Attachment C to
Comments of APGA, et al.
Docket No. EERE-2018-BT-STD-0018
RIN 1904-AE39
Filed October 12, 2021

Comments of AHRI

Re: Proposed Rule Energy Conservation Standards for Residential Furnaces;
Docket Number EERE-2014-BT-STD-0031

Figure 13: DOE Assumed Consumer Discount Rates

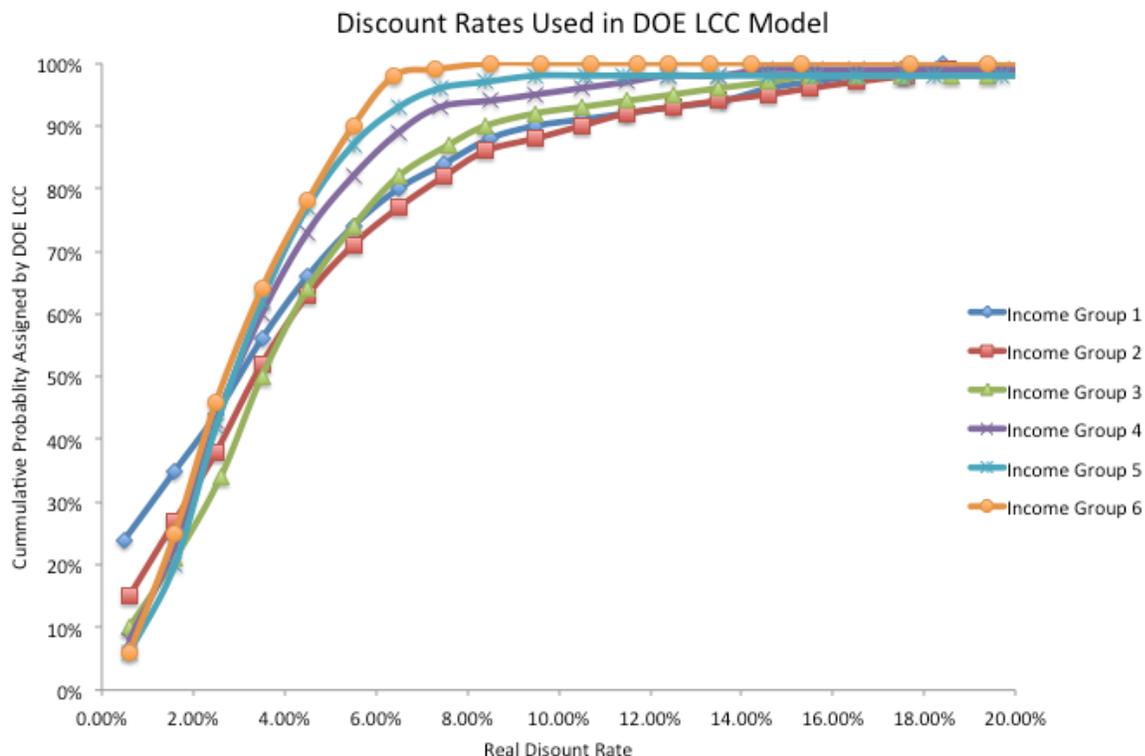
In this context, the DOE assumed real discount rates appear to be improbable representations of the actual financial situations faced by consumers. In its LCC, DOE has average discount rates of (Figure 13):⁵⁹

The true marginal discount rates for consumers are much more likely to cluster around 8-9% than around 3-5%. First, as demonstrated by both reasonable analysis of consumer balance sheets and the survey data, only a minority of consumers will be able to use cash or other savings in order to pay for a furnace replacement. Even then, cash is not a low/no cost source of funds since it must be replaced with high cost funds or deferred consumption in order to rebuild the liquidity cushion. The marginal source of funds for most consumers is credit card debt (estimated by DOE at 14.2-15.0% interest rate)⁶⁰. According to the American Housing Survey, only 7% of respondents had home equity loans or lines of credit (the lowest cost of borrowing for most consumers).⁶¹ (While home mortgages are also a low cost source of funds, the transaction costs and time for refinancing a mortgage make first mortgages an unlikely source of funds for a furnace replacement.) A small portion of households in Income Groups 5 and 6 may be able to finance a furnace replacement by drawing on non-retirement savings. However, these will also have a cost of funds estimated by DOE at 4.2% for debt to 9.2% for equities.⁶² While this may yield an average cost of consumer capital below 8-9%, it is unlikely that DOE wishes to justify standards on the ability of the upper 10% of consumers to finance them at relatively lower costs of capital.

Figure 14: DOE vs. Contractor Survey Furnace Installation Costs – North

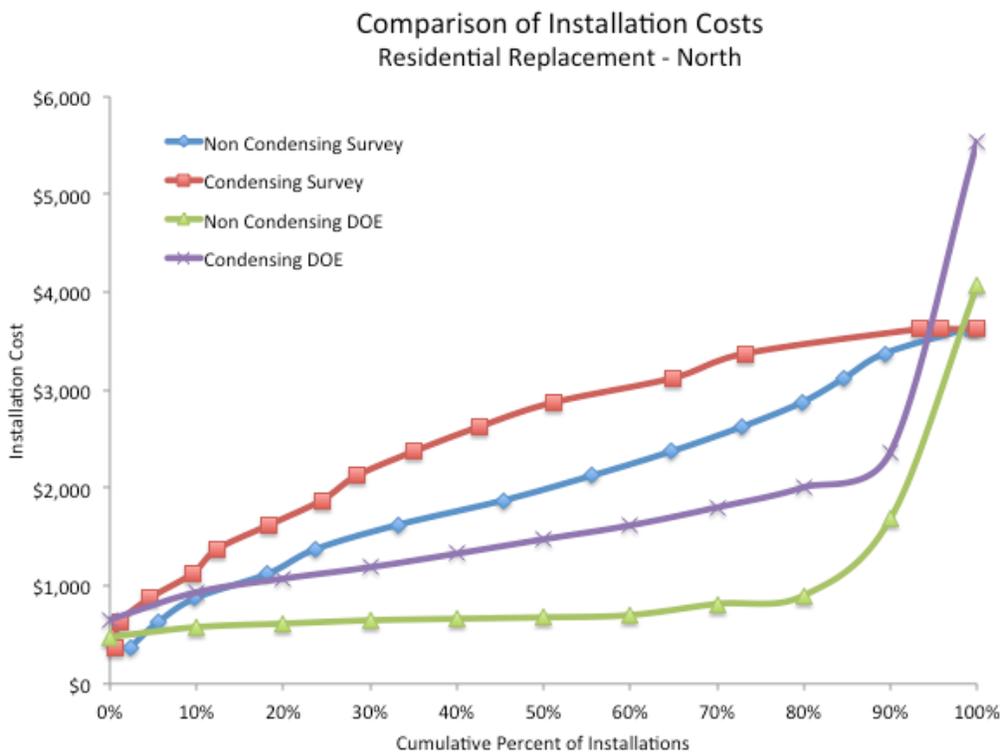
The total distribution of costs shows a consistent pattern of DOE underestimating the cost of installation (Figure 14 & Figure 15).

Figure 19: DOE Furnace TSD Figure 8C3.3

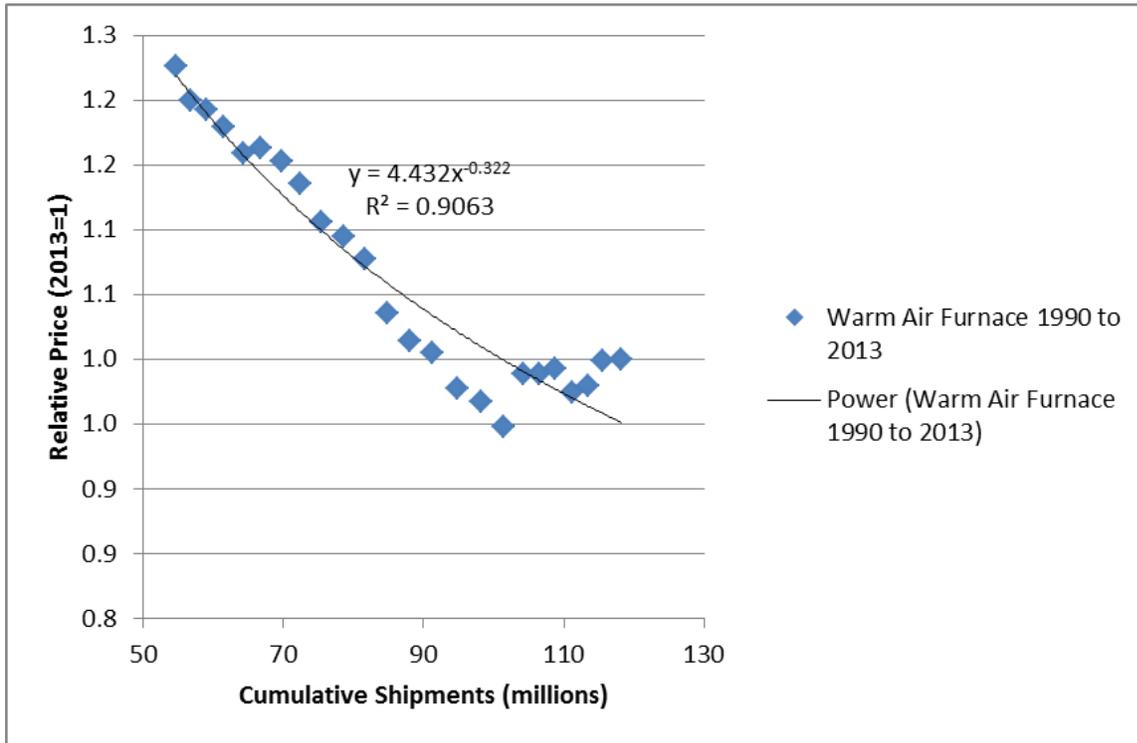
The importance of data and taking it as it comes can be seen through Figure 8C.3.3 in the Furnace TSD (Figure 19). It appears that there has been a structural change in the price/shipment relationship for the final seven data points. DOE chose to fit a single curve through all its data points rather than the more obvious solution of starting a separate curve for the final seven. Victor Franco, for DOE, stated: “we fit basically, we do the best fit to that curve.” By inspection (Figure 20), there would be a better fit by drawing two curves. One would go through the last seven data points and one would go through the others. However, this can only be inferred by inspection since DOE has not responded to AHRI’s request to release the actual numerical data behind the graphs.⁷¹

Figure 21: LCC Projected Fuel Use for 80 AFUE Furnaces

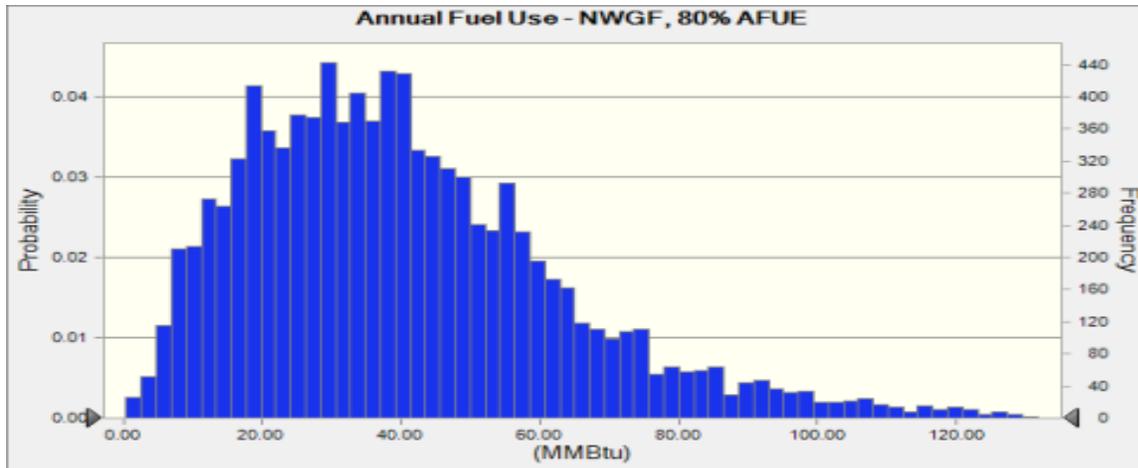
There is also something quite odd in the calculation of Annual Fuel Use. As can be seen from the graphs, the fuel use for 80 AFUE furnaces has a plausible distribution (Figure 21):⁸⁰

Figure 22: LCC Projected Fuel Use for 90 AFUE Furnaces

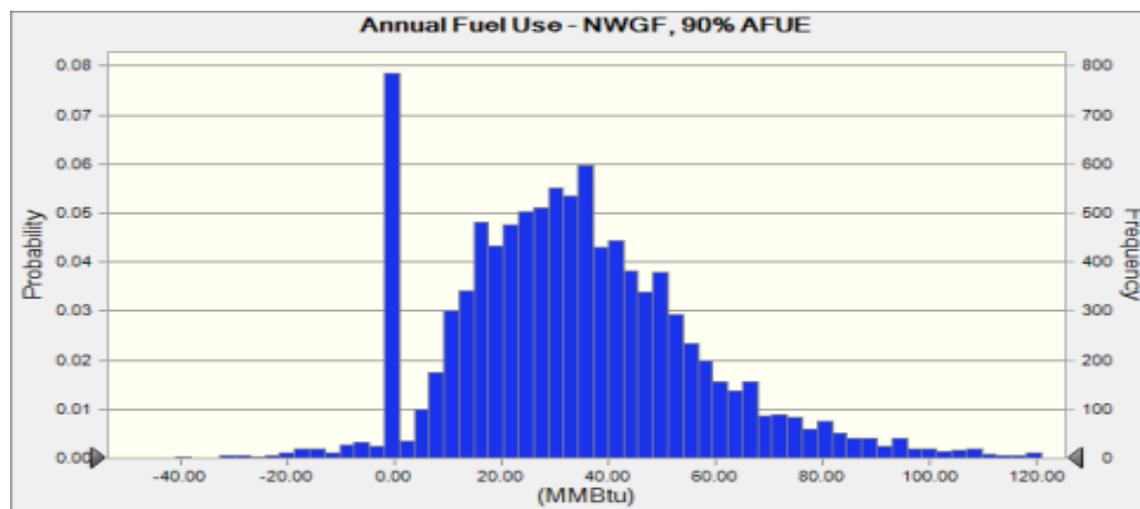
However, the fuel use for 90 AFUE furnaces has a very odd distribution (Figure 22):

Again, while it is not practical to debug the LCC model, the large value at zero fuel use and the negative values are highly unlikely to be real reflections of actual conditions. The negative fuel uses are unlikely to represent gas wells on peoples' properties. Something is significantly wrong with the DOE LCC model if it is projecting zero and/or negative fuel use.
